SERVICE LETTER 126
PAGE 1 of 2 REV: B

SERVICE LETTER NUMBER 126			
TITLE: STERN BULKHEADS, LOWER FLANGE REINFORCEMENT			
BY: K. TAYLOR	AIRCRAFT MAKE/MODEL(S): FIREBOSS AIR TRACTOR 802 & 802A	FLOAT MODEL(S): 10000	NOTE(S): OPTIONAL COMPLIANCE S/L P/N 1005511 ECO 22619
APP: R. ADLER			
DATE: 7-DEC-11			
REV: B

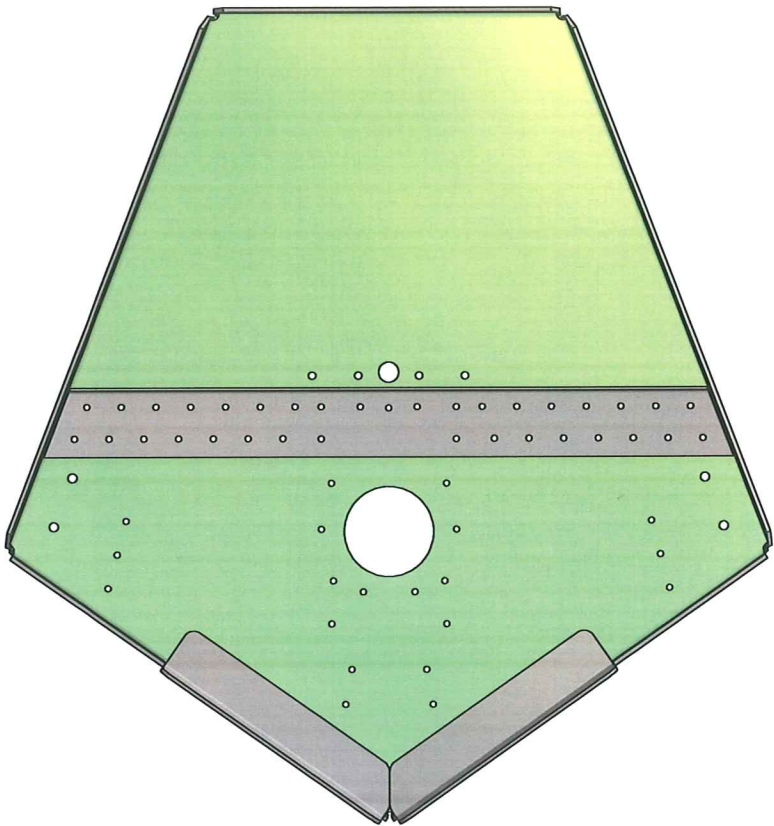
Certain aircraft operated in rough water or operated in a high-cycle water scooping environment may experience cracking of the lower stern bulkhead flanges below the lower water rudder post attachment. This service letter and associated kit reinforce the lower bulkhead flanges of the stern bulkheads to assist in load transfer and reduce probability of cracking.

To accomplish this modification: Install lower angle doublers P/N 1005621 and 1005622 on the forward side of hull bulkhead station 22 in accordance with modification drawing P/N 1005529, latest approved revision. Follow the detailed instructions on the modification drawing to install the angles. The doubler should be installed on both the port and starboard hulls. For reference, the stern bulkhead assembly is P/N 1002681. The angles tie the bottom skin to the bulkhead and reinforce the structure.

VIEW LOOKING AFT
FWD FACE OF HULL STATION 22
MODEL 10000 FLOAT

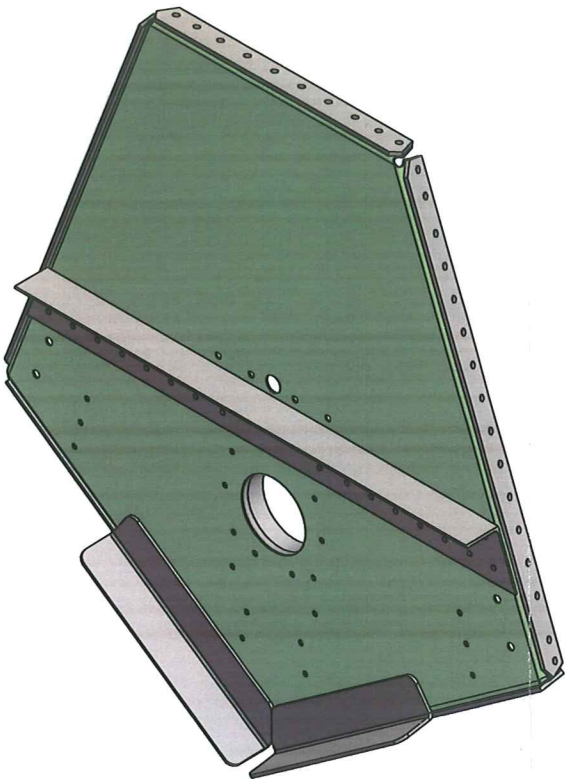
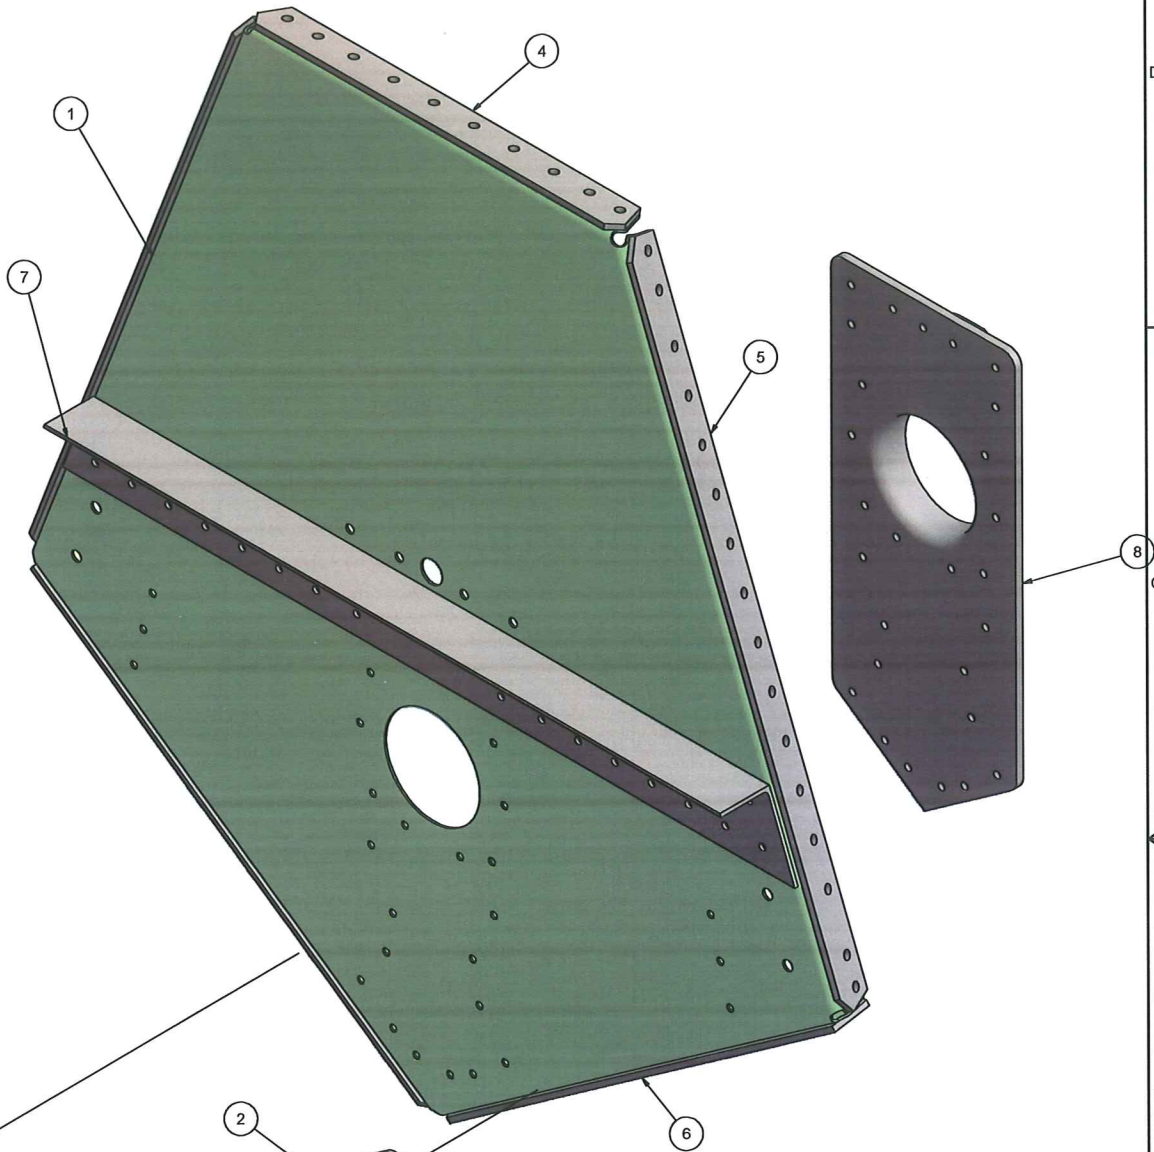
REVISION HISTORY					DESCRIPTION
REV	DATE	ECO	DR		
A	4-OCT-11	22530	DKS		INITIAL RELEASE
B	12/7/11	22619	DKS		REMOVED DOUBLER ADDED ANGLES (ITEMS 2, 3)

- THIS DRAWING SPECIFIED MODIFICATION OF THE STATION 22 STERN BULKHEAD ON WIPAIRE MODEL 10000 FLOAT.
- THE PURPOSE OF THIS MODIFICATION IS TO REINFORCE THE STERN BULKHEAD TO HELP PREVENT CRACKING DUE TO WATER RUDDER LOADS.

- TO INSTALL ANGLE P/N 1005621 AND 1005622, PERFORM THE FOLLOWING OPERATIONS:
 - UNSEAL AND REMOVE THE AFT-MOST TOP DECK COVER TO GAIN ACCESS TO THE FORWARD SIDE OF THE STA. 22 BULKHEAD.

- REMOVE WATER RUDDER ASSEMBLY FROM WATER RUDDER POST. SECURE RETRACTION AND STEERING CABLES.
 - BRIEFLY POSITION ANGLE P/N 1005621 AND 1005622 ON THE FORWARD SIDE OF THE STA. 22 BULKHEAD. IDENTIFY AND DRILL ALL INTERFERING RIVETS (6 PLACES) IN THE STERN BULKHEAD. THESE RIVETS WILL BE MATCH DRILLED TO THE ANGLES.

- WITH HOLES IN THE ANGLES AND HULL, POSITION AND CLECO ANGLES IN PLACE.
 - WITH ANGLES SECURED WITH CLECOS, DRILL BULKHEAD AND ANGLES FOR #4 DIA. RIVETS, 16 PLACES.

- DRILL BOTTOM SKIN AND ANGLES FOR #5 DIA. RIVETS, 18 PLACES.
 - REMOVE ANGLES AND DEBURR ALL RIVET HOLES.
 - INSTALL ANGLES WET WITH SEALANT, DRIVE ALL RIVETS WET. RIVETS FROM BULKHEAD TO ANGLES SHALL BE MS20370AD4. RIVETS FROM ANGLES TO BOTTOM SKIN SHALL BE MS20470AD5. ALL RIVET LENGTHS AS REQUIRED. RECOMMENDED LENGTHS LISTED IN SERVICE KIT 82.

- AFTER SEALANT HAS CURED, REINSTALL WATER RUDDER AND RETRACT/STEERING CONNECTIONS.
 - PERFORM OPERATIONAL CHECK OF RETRACT AND STEERING SYSTEM.
 - REINSTALL STERN TOP DECK COVER WITH FRESH SEALANT.
